# UNITED STATES PATENT AND TRADEMARK OFFICE

APPLICATION NO.	FILING DATE	FIRST NAMED INVENTOR	ATTORNEY DOCKET NO.	CONFIRMATION NO
10/014,227	12/11/2001	Benoit R. Veillette	US010594	3093
24737 7:	590 01/18/2006		EXAMINER	
PHILIPS INTELLECTUAL PROPERTY & STANDARDS			TAYLOR, BARRY W	
P.O. BOX 3001 BRIARCLIFF MANOR, NY 10510			ART UNIT	PAPER NUMBER
Divince In than to the second			2643	
		DATE MAILED: 01/18/2006

Application No.	Applicant(s)
	10/014,227	VEILLETTE, BENOIT R.
Office Action Summary	Examiner	Art Unit
	Barry W. Taylor	2643
The MAILING DATE of this communication a Period for Reply	ppears on the cover sheet with th	e correspondence address
A SHORTENED STATUTORY PERIOD FOR REP WHICHEVER IS LONGER, FROM THE MAILING  - Extensions of time may be available under the provisions of 37 CFR after SIX (6) MONTHS from the mailing date of this communication.  - If NO period for reply is specified above, the maximum statutory period.  - Failure to reply within the set or extended period for reply will, by state Any reply received by the Office later than three months after the mail earned patent term adjustment. See 37 CFR 1.704(b).	DATE OF THIS COMMUNICATI 1.136(a). In no event, however,

FIG. 1

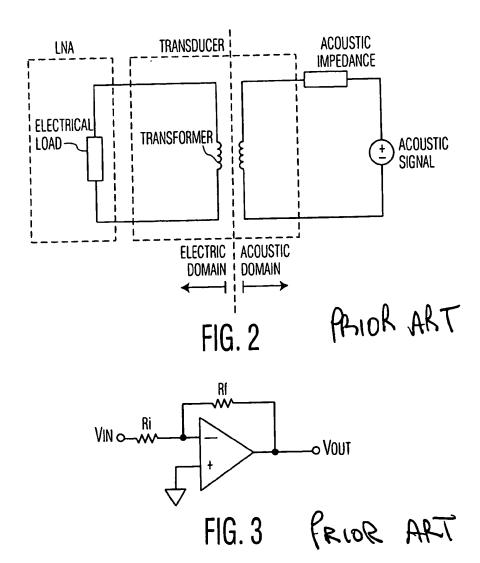
Regarding claim 1. Applicants openly admit that prior art teaches a receiver circuit (see RECEIVER in figure 1), comprising:

a switch for blocking high voltages and for converting voltage signals to current signals (see T/R switch in figure 1), said switch comprising first and second signal terminals (see conventional T/R switch depicted in figure 4B wherein first terminal is labeled as 405 and second terminal labeled as 410) and a control terminal (see control terminal labeled as 400 figure 4B) said switching exhibiting an ON resistance when closed, said ON resistance controlled by an electric value at said control terminal;

Regarding claim 8. Applicants openly admit that prior art teaches a receiver circuit (see RECEIVER in figure 1), comprising:

a T/R switch for blocking high voltages and for converting voltage signals to current signals (see T/R switch in figure 1), said T/R switch comprising first and second signal terminals (see conventional T/R switch depicted in figure 4B wherein first terminal is labeled as 405 and second terminal labeled as 410;

FIG. 6

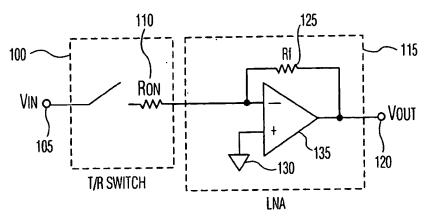
According to Applicant, prior art (i.e. Applicants figure 5) fails to use control circuit (i.e. see transducer output "Vin" in Applicants figure 6) coupled to the T/R switch shown in Applicants figure 5 (see amendment to claims and remarks, paper dated 11/7/05).

According to Applicant, prior art (i.e. Applicants figure 5) fails to use control circuit (i.e. see transducer output "Vin" in Applicants figure 6) coupled to the T/R switch shown in Applicants figure 5 (see amendment to claims and remarks, paper dated 11/7/05).
